# Staff Report

Devens  
Enterprise  
Commission

**RE:** 18 Independence Expansion - Level 2 Unified Permit (#D25-006)

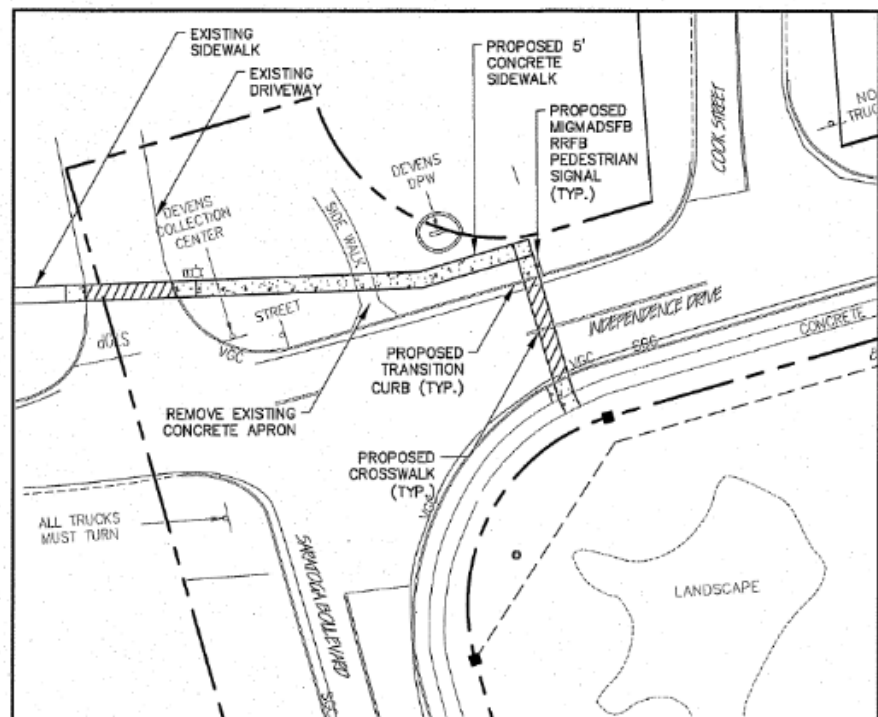
SMC is a medical device manufacturer and they will be expanding their existing operations. Bio-manufacturing uses are permitted in the Rail, Industrial, and Trade Related Uses District. The existing parcel is 21.6 acres, exceeding the two acre required minimum and has well over 100' of frontage on both Saratoga Boulevard and Independence Drive. The proposed addition is outside of all the required front, side and rear yard setbacks. Because the proposed building expansion is being located on an existing paved loading dock and parking lot area, the overall increase in impervious is fairly minor given the size of the expansion (1.08 acres or 47,045 sq.ft.). The Zoning table on Sheet 5 of the plan set has a number of discrepancies that the Applicant will need to address on the final plan set.
